NATIONAL AERONAUTICS AND SPACE ADMINISTRATION

DOCKET NO. 50-30

AMENDMENT TO FACILITY LICENSE

Amendment No. 8
License No. TR-3

FIGURE 1

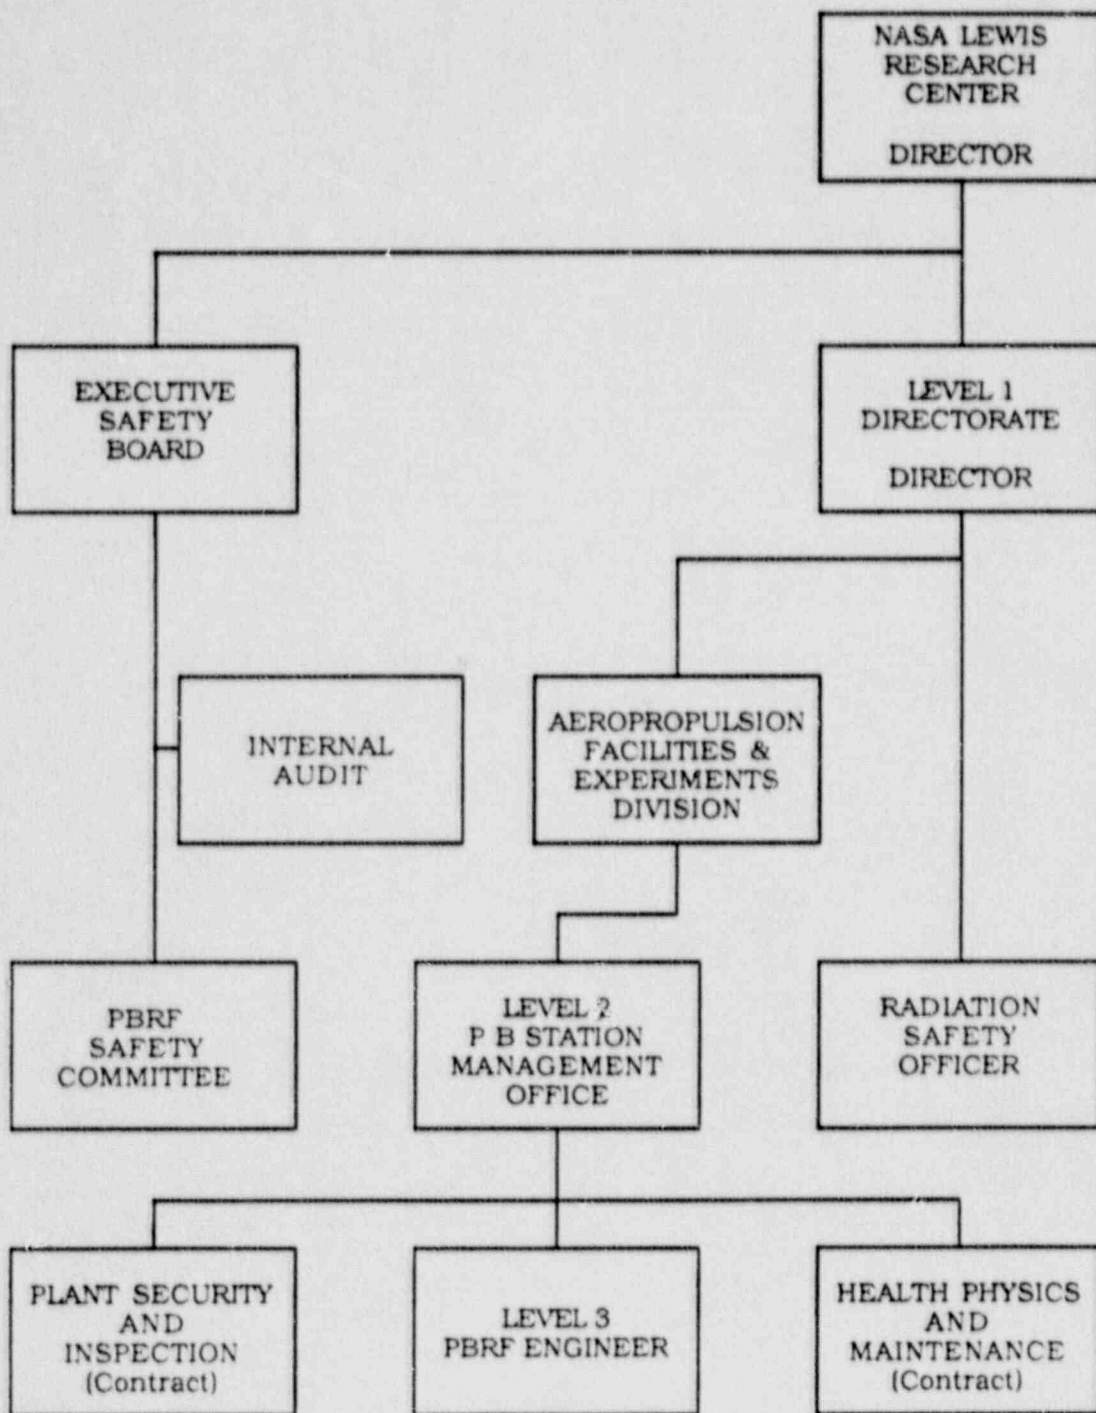
The Plum Brook Reactor Facility is owned by the National Aeronautics and Space Administration (NASA), which shall be responsible for maintaining the protection safe storage condition as required by these Technical Specifications. NASA shall provide whatever resources are required to maintain the PBRF in a condition that poses no hazard to the general public or to the environment. Figure 1 charts the generic organization.

3.1.1 Level 1 Directorate

The Director shall be responsible for assuring compliance with the reactor facility's license and for providing regulatory reports and correspondence. He shall have overall responsibility for the protected safe storage of the facility.

3.1.2 Aeropropulsion Facilities and Experiments Division

This Division shall provide the resources to maintain the PBRF in protected safe storage and is under the management of a Level 1 Director.
